# Amphenol PCD

Engineering Change Request		ECR Number	R09332W
Initiator:	Flame.Li	Date:	2026.06.10

The CHD14021 series 180° socket has undergone adjustments and optimizations to its internal black plastic structure for the following reasons:

Using the A key as an example:

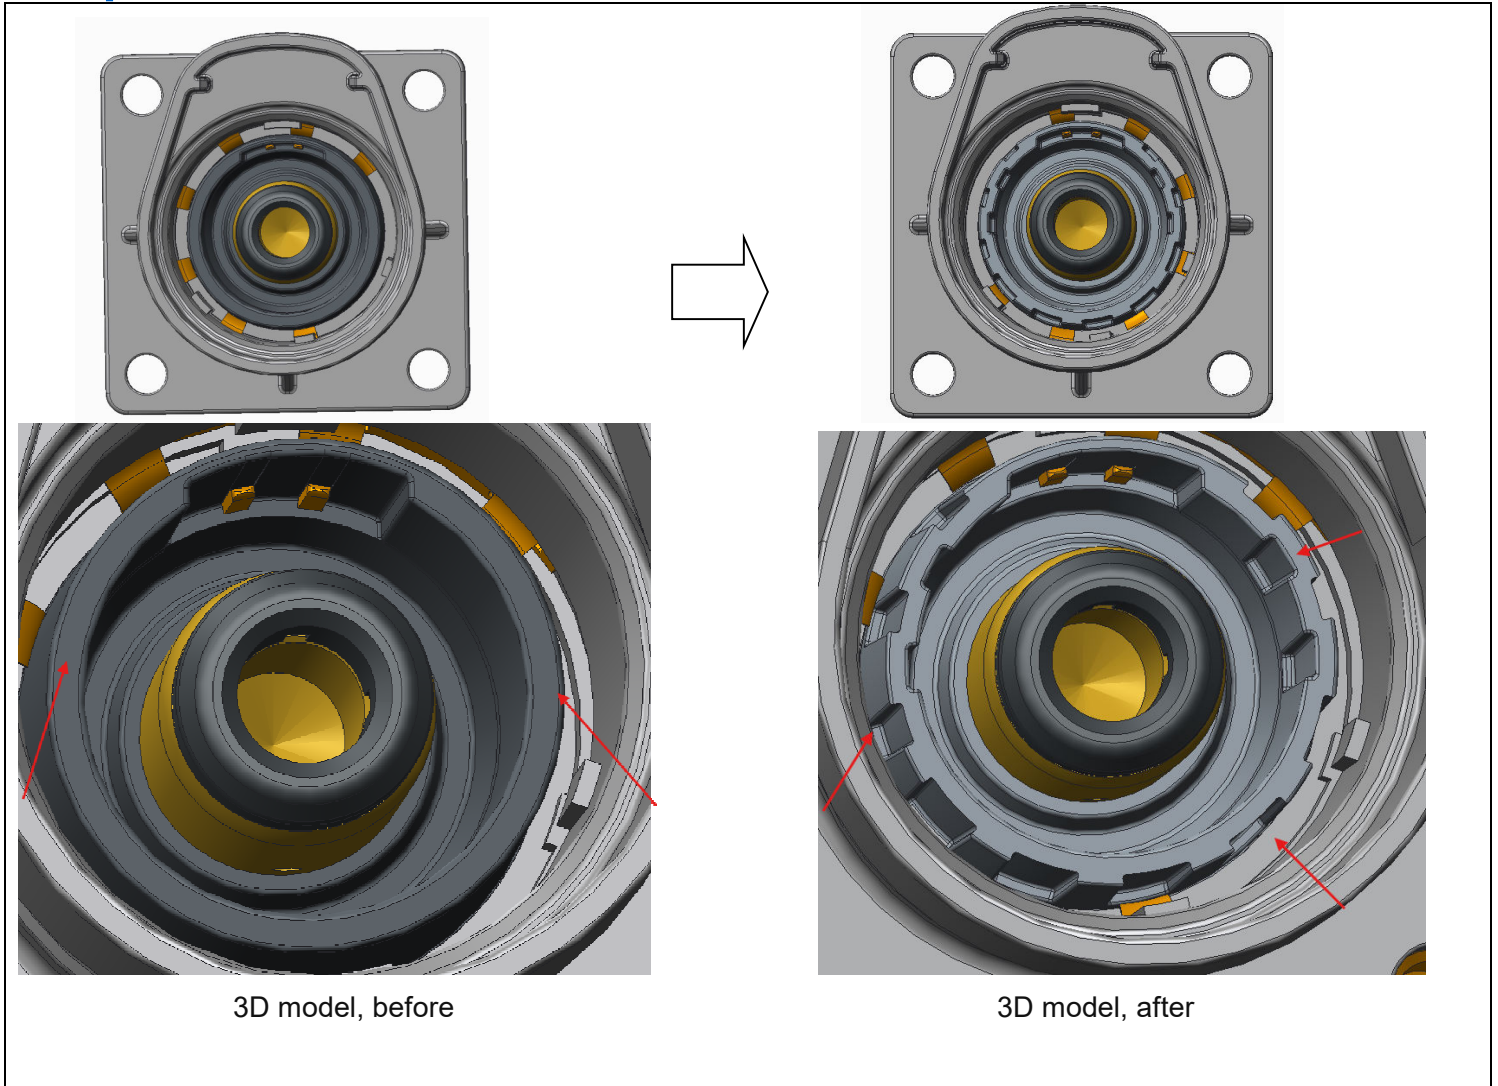
The current plastic parts have relatively thick walls. This adjustment involves reducing the wall thickness of the plastic parts to optimize the injection molding process.

This change does not affect product performance; the old materials can still be used normally, allowing for a natural transition between the old and new materials.
